North Anna Unit No. 1
Technical Specifications Changes
 $T_{avg} = 587.8^{\circ}\text{F}$

North Anna Unit No. 2

Technical Specifications Changes

FIGURE 2.1-1 REACTOR CORE SAFETY LIMITS FOR THREE LOOP OPERATION, 100% FLOW

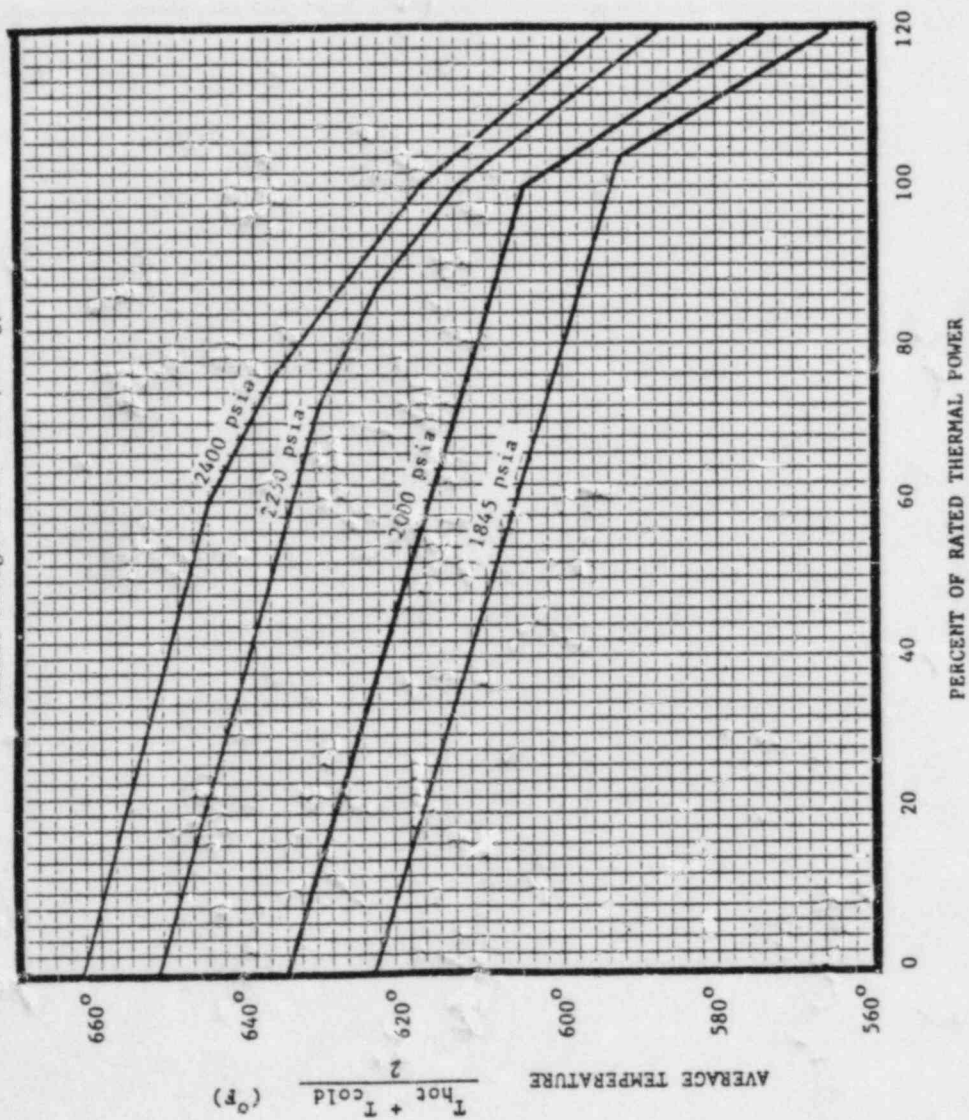
$T_{avg} = 587.8^{\circ}F$

Nominal Tav_g: 587.8°F
 Nominal Design Flow: 285,000 gpm
